**WEST HAYMARKET PARKING DECK NO. 1
Deck 1 GMP Set
ADDENDUM NO. 3**

PROJECT: West Haymarket Joint Public Agency
Lincoln Haymarket Infrastructure Team
Parking Deck No. 1
Lincoln, Nebraska

AD-3

DATE ISSUED: Tuesday, August 21, 2012

1 Cable Guard Detail
1 1/2" = 1'-0"

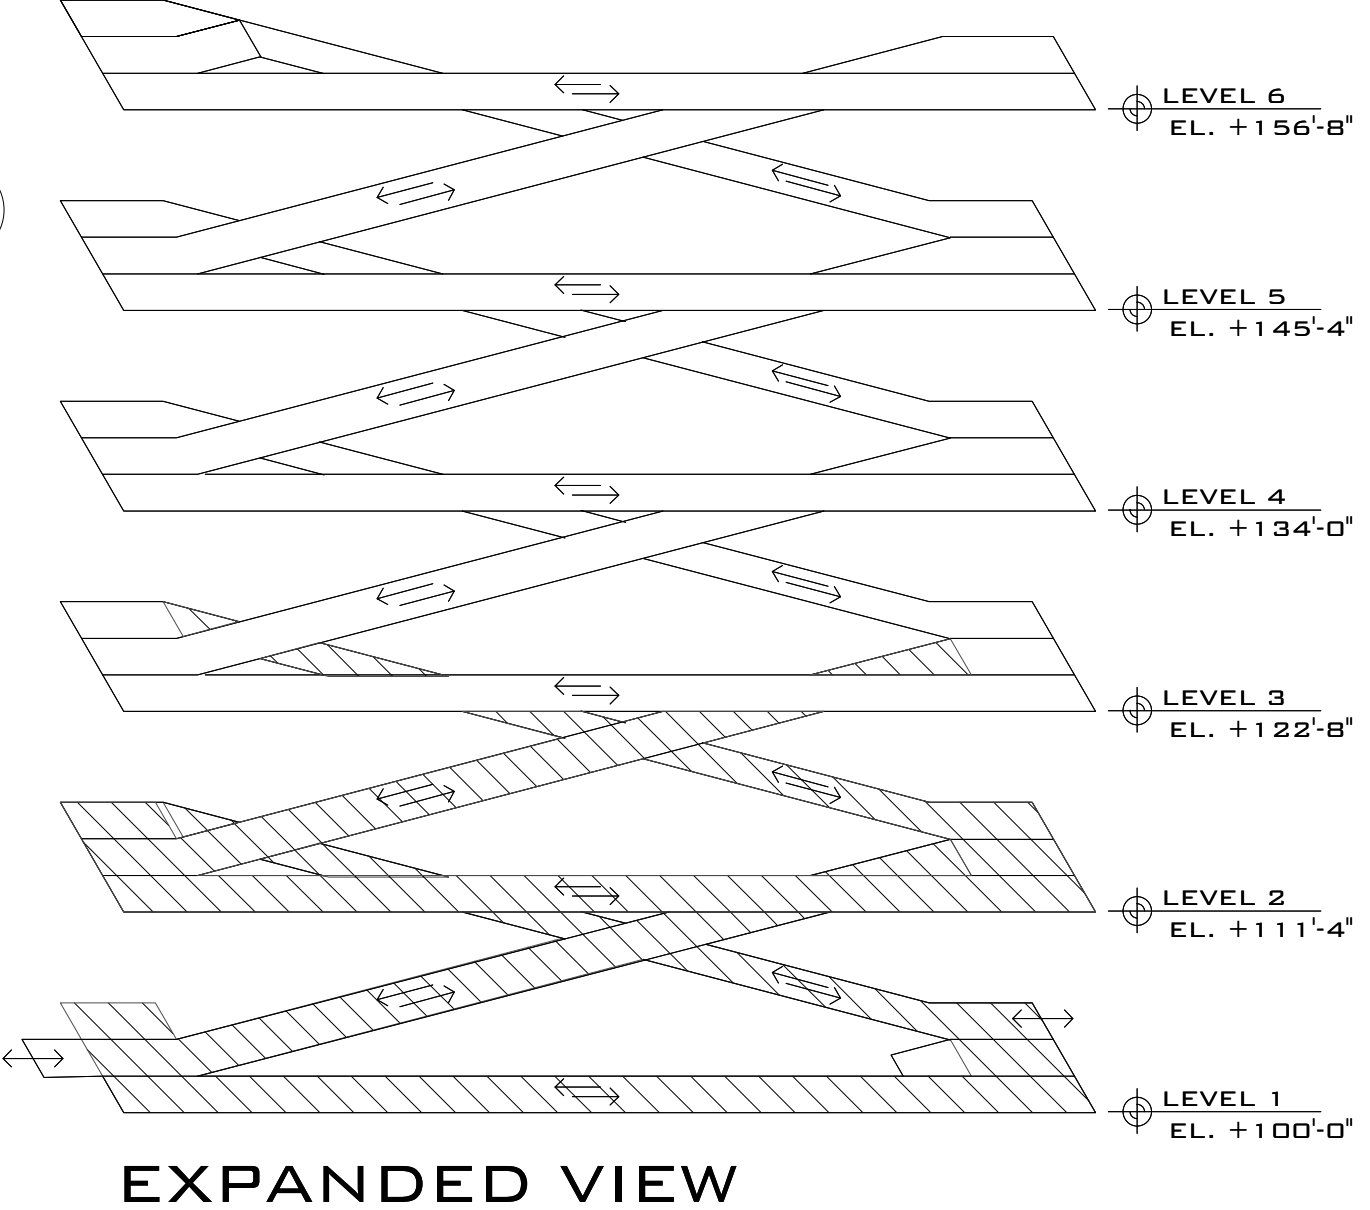
The cable barrier system indicated as 11 strands each on elevations 3/A-210 East Elevation Grid "C" (Looking West), 1/A-211 West Elevation Grid "B" (Looking East) and 2/A-211 East Elevation Grid "B" (Looking West) is to be revised to a 5 cable system with chain link fabric as detailed on attached Supplemental Drawing A-506.1. The cable barrier system at all other locations is to remain as originally detailed.

CABLE RAIL DETAIL FOR INTERIOR LIGHT WALLS AT FOLLOWING LOCATIONS:

EAST SIDE OF GRID "C" ALL LEVELS
WEST SIDE OF GRID "B" ALL LEVELS
EAST SIDE OF GRID "B" ALL LEVELS

Drawing #
24A/S-303

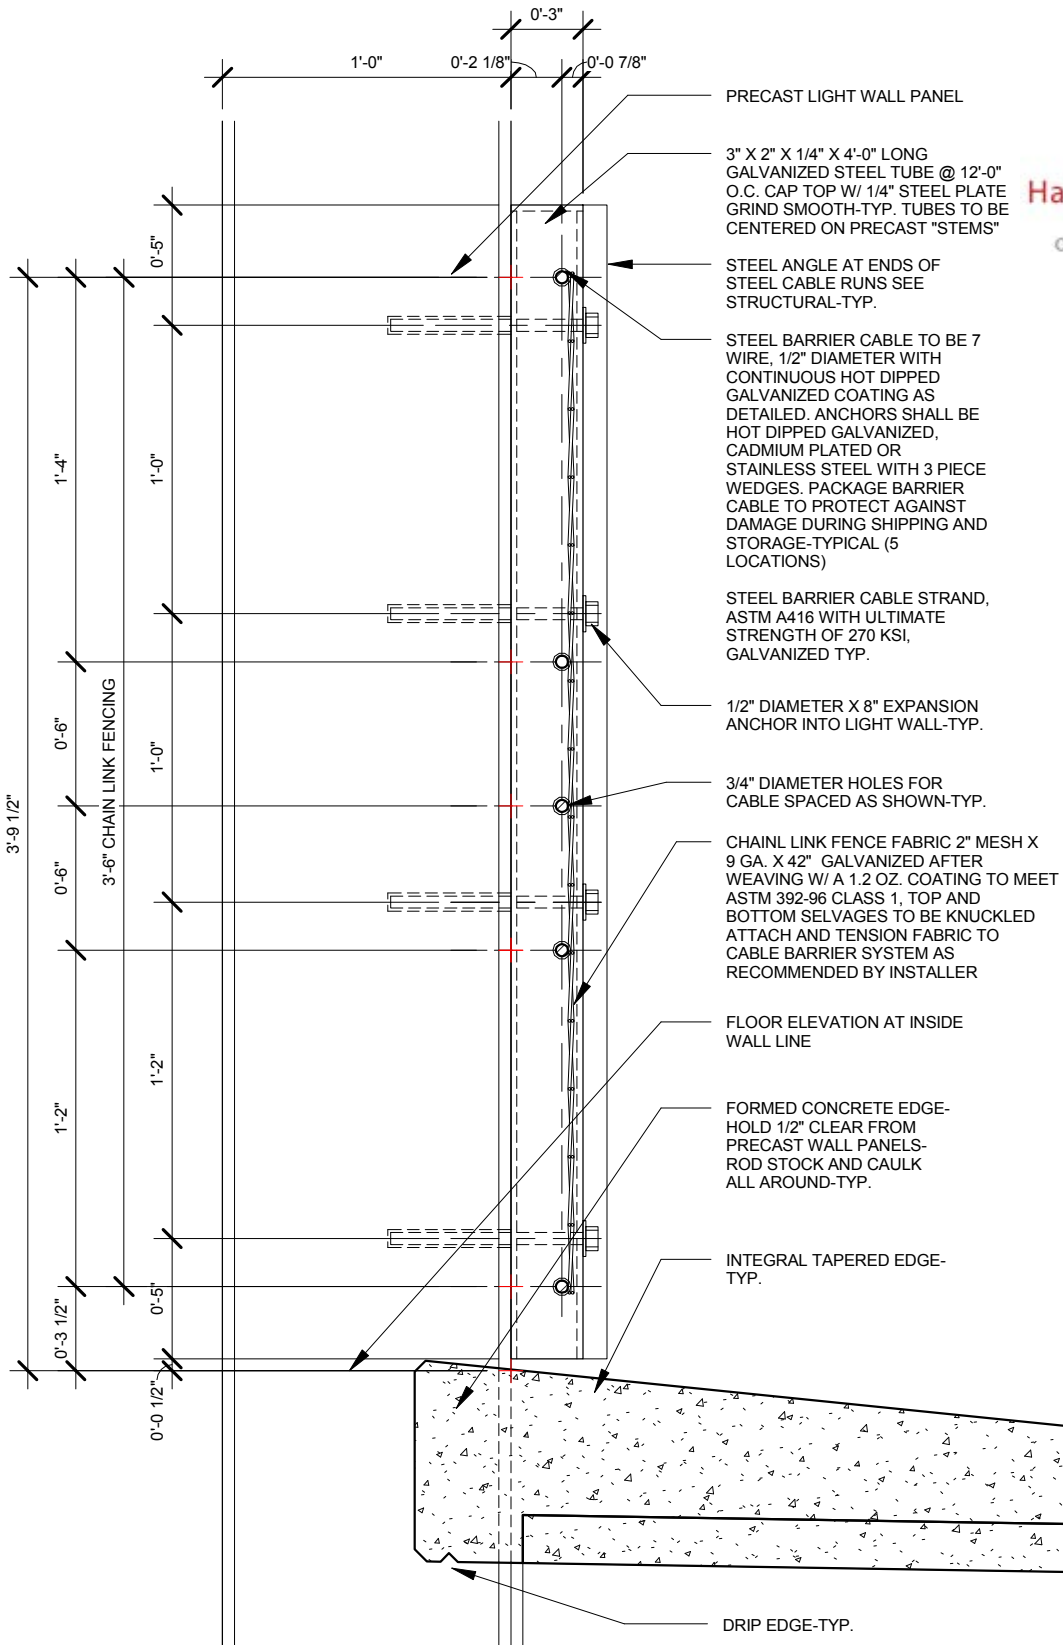
In reference to Sheet S-303, in lieu of precast haunch construction shown for the barrier cable anchor locations on D24/S-303, provide an embed and angle as shown on attached Supplemental Drawing D24a/S-303. Coordinate hole locations for strand as shown on the original drawings and as changed per Supplemental Drawing A-506.1.

NOTE:
PROVIDE MINIMUM OF
(6)-1/2" DIA.x6" HEADED
STUDS AND (2)- #4 TALE
BARS AT EACH LIGHT WALL
SECTION

1/2" 7-WIRE 250 KSI BARRIER CABLE
GALVANIZED PER ASTM A475, SEE
ARCH. DWGS. FOR LOCATIONS AND
AMOUNTS

8" WIDEx3/4" THICKxLENGTH AS REQ'D.
FOR 4" TOP AND BOTTOM OF ANGLE
(GALVANIZE AND PROVIDE (2)-1/2"
DIA.x6" HEADED STUDS AT 4" o.c.)

ANCHOR/STRAND
CHUCKS AND WEDGES
BY CABLE SUPPLIER
L4x4x3/4" (GALVANIZED) w/ HOLES FOR
1/2" DIA. 7-WIRE STRAND AT 4"
o.c.(PROVIDE 3" ANGLE ABOVE AND BELOW
CENTER OF TOP AND BOTTOM
STRANDS-COORD. STRAND LOCATIONS w/
ARCH. DWGS.-TYP.)

APPLIES AT ALL BARRIER CABLE ANCHOR
LOCATIONS-CONTRACTOR COORDINATE DEAD MAN, JACKING
LOCATIONS, CLEARANCES, AND TIMING WITH INSTALLER AND
PRECAST ERECTOR

1 Revised Mechanical Room Elevation
1" = 1'-0"

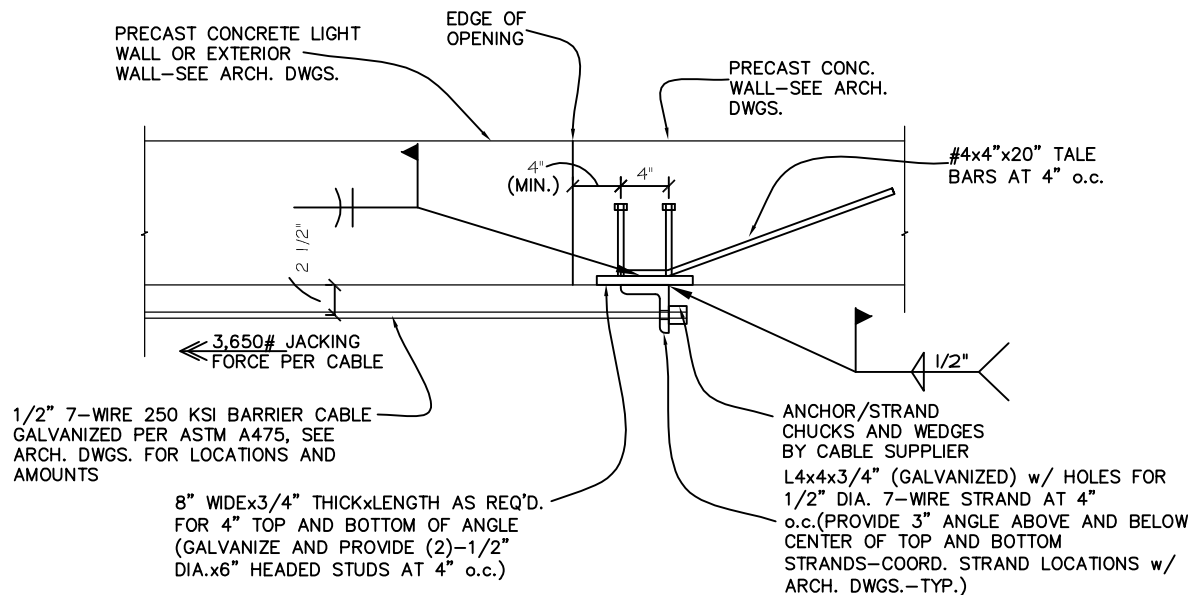
In reference to sheet M-301, revise Mechanical Room Elevation per attached Supplemental Drawing M-301.1. Dimensions and clearances for water service entrance shall be as outlined in the City of Lincoln Water Service Manual. A 2" deduct meter and 2" reduced pressure zone backflow preventer shall be added to serve lawn irrigation. A 2" reduced pressure zone backflow preventer shall be added to serve the 2" domestic cold water line for parking garage wash down.

4 Lighting Control Schematic

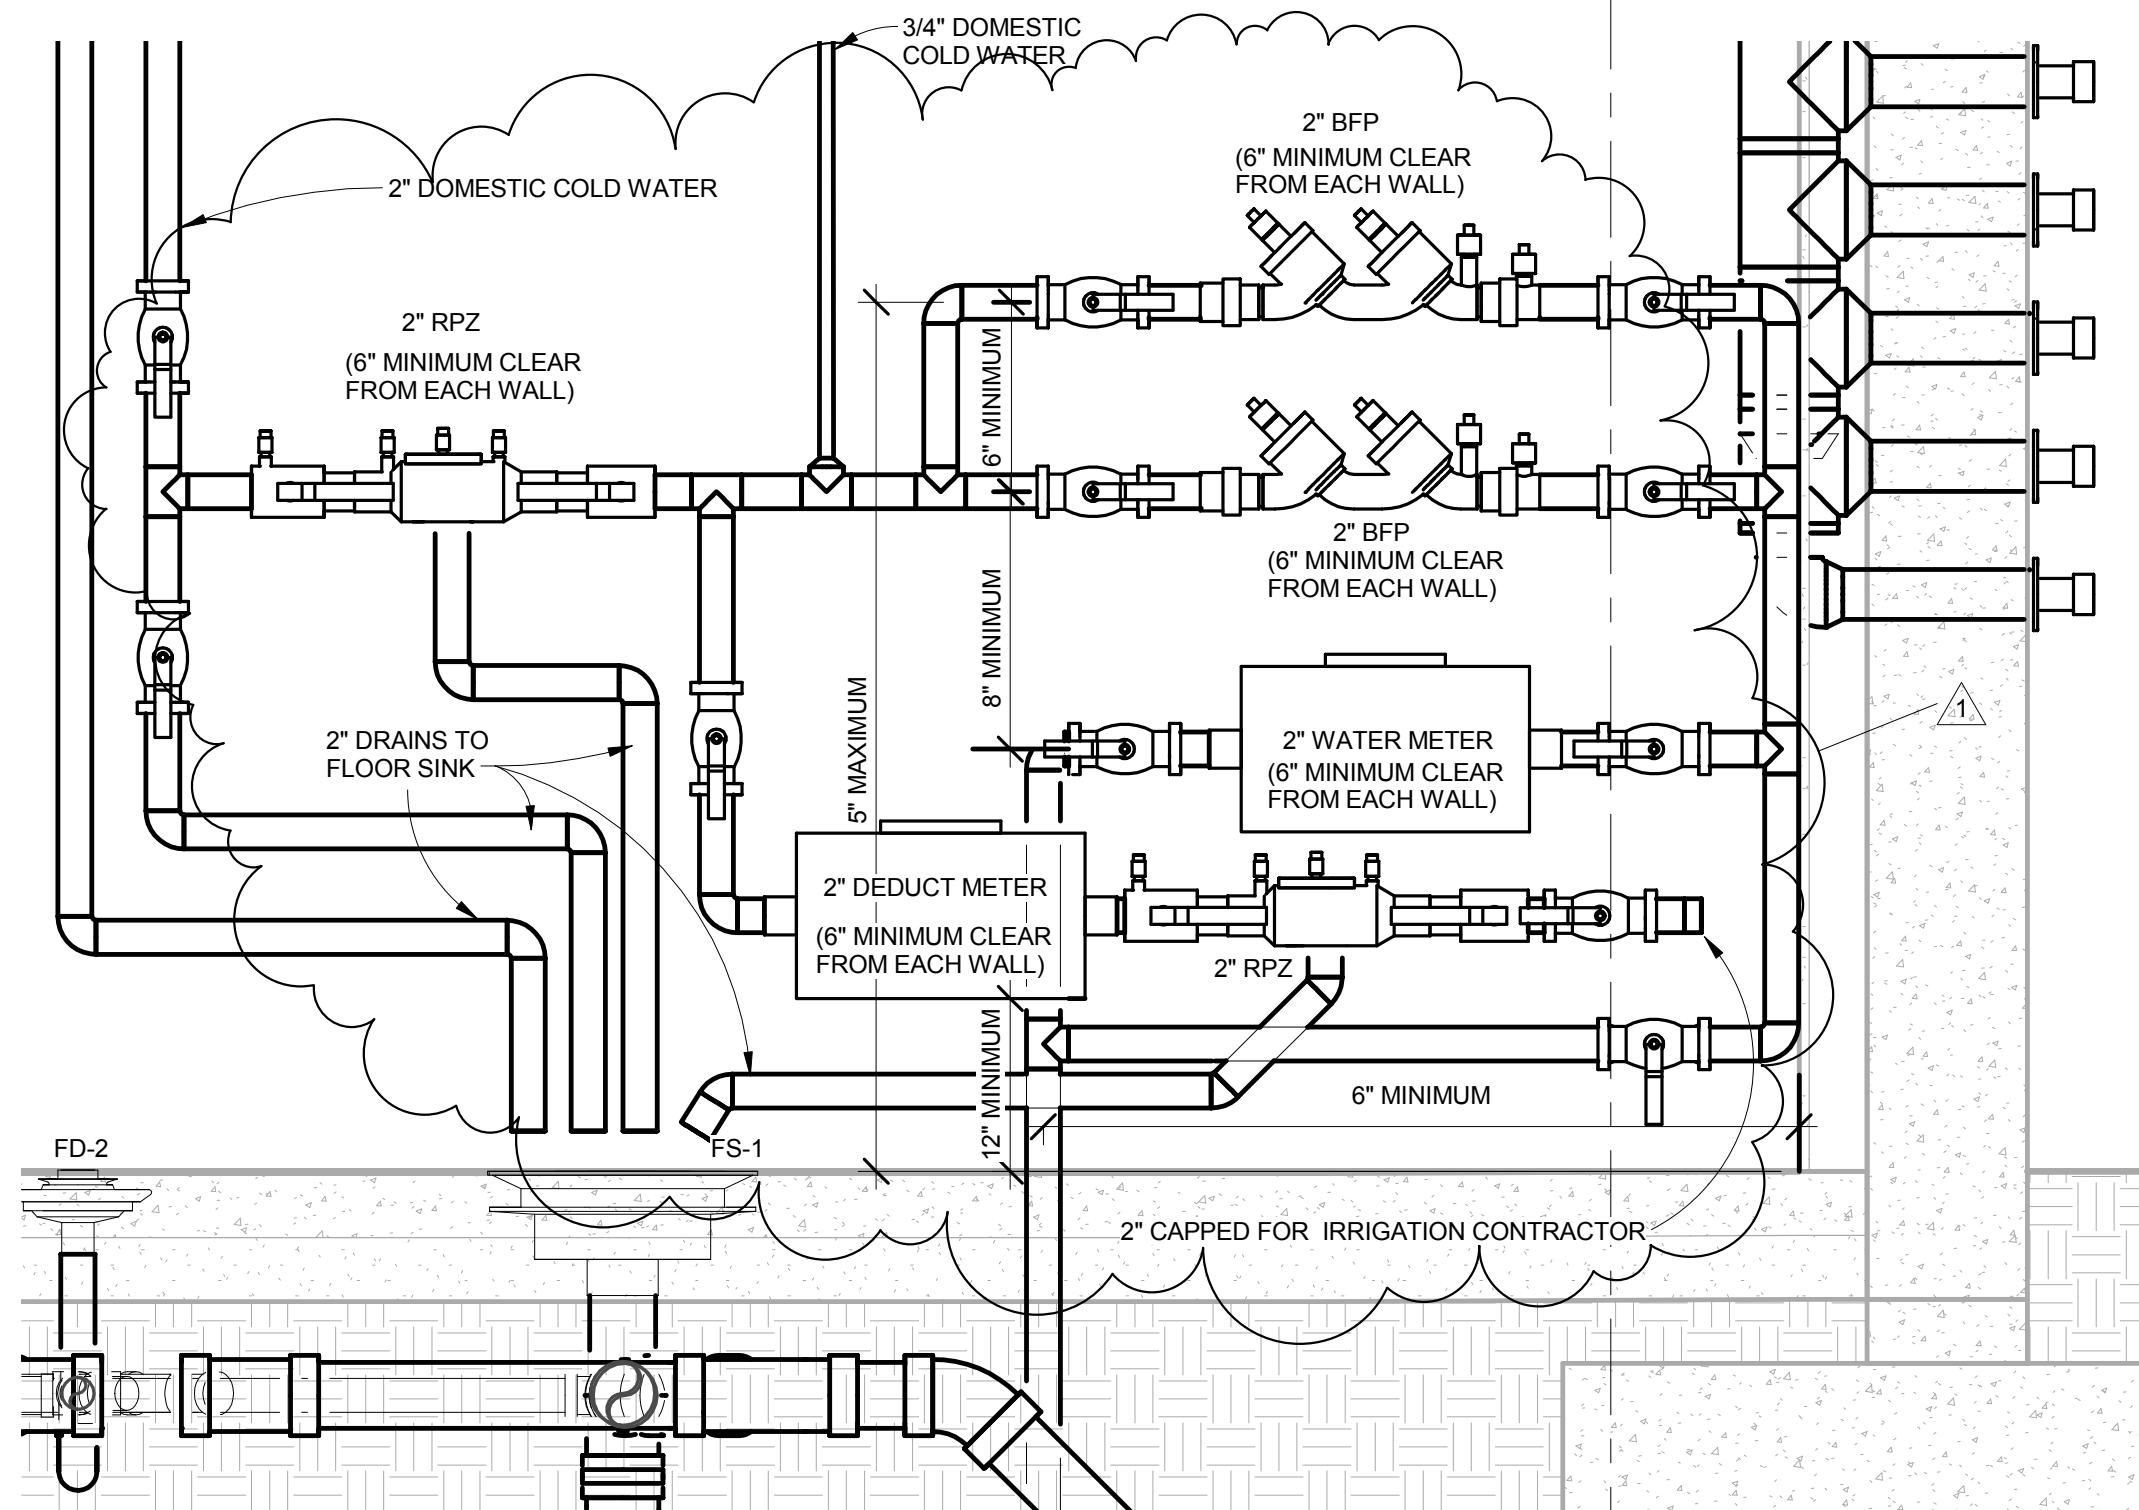
In reference to Sheet E-502, revise Detail 4 per attached Supplemental Drawing E-502.1.

3 8KW CENTRAL EMERGENCY LIGHTING INVERTER. DOUBLE CONVERSION, FULLY ONLINE OPERATION WITH COMPLETE INPUT/OUTPUT ISOLATION. UL 924 LISTED, WITH BATTERY PROVISIONS FOR 90 MINUTES OF RUNTIME AT FULL LOAD. PROVIDE WITH BATTERY EXERCISER, SELF-DIAGNOSTIC & SELF-TESTING SYSTEM, AUXILIARY FORM C CONTACTS AND OUTPUT TRIP ALARM. MYERS POWER PRODUCTS, INC. ILLUMINATOR CIII SERIES I-D-3-S OR EQUAL. PROVIDE WITH INTEGRAL OUTPUT CIRCUIT BREAKERS AS SHOWN HERE, INCLUDING WITH TWO SPARE 20/1 OUTPUT CIRCUIT BREAKERS.

Drawing Title
Revised Inverter
(Panel E) Schedule

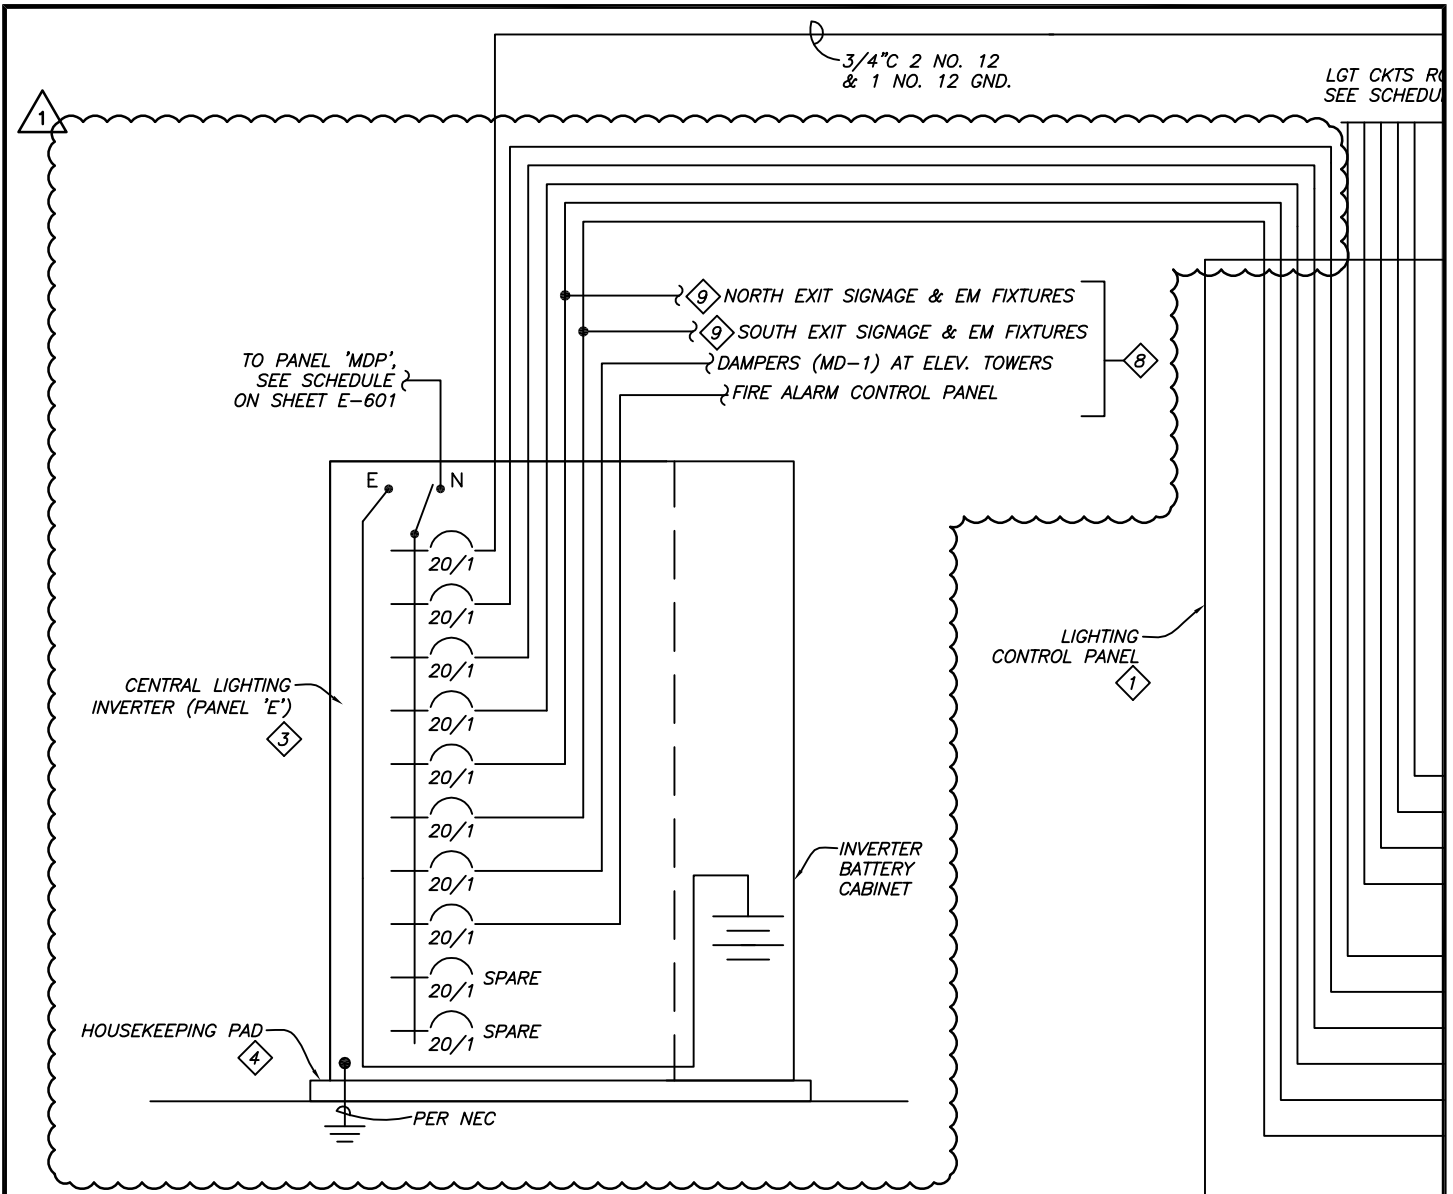
In reference to Sheet E-601, revise Panel Schedule per attached Supplemental Drawing E-601.1.
